Engineering Note			
Title:	RBX-PCB-EX02-C1 to C2 Extruder PCB mod sheet		
Project:	CEL Robox	No.	RBX-PCB-EX02-C1
Engineer:	Pete Tarver	Date:	09/11/2021
Pages:	5

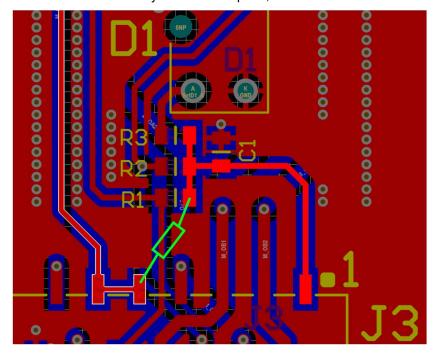
During testing of the rev C1 assembly the following changes have been found necessary for a more robust, noise filtering, solution:

- 1. 10K resistor fitted between 3V3 and GND SWITCH
- 2. SN74LVC1G17DBVR schmitt buffer added between the optical sensor output and the connector

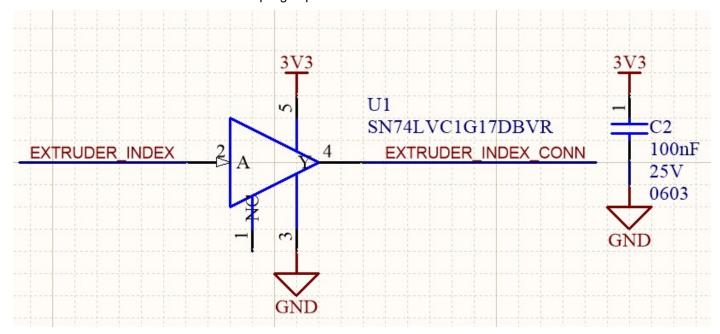
1. Add resistor: directly solder to R1 pin 1, and wire link the other end to J3 pin 9:
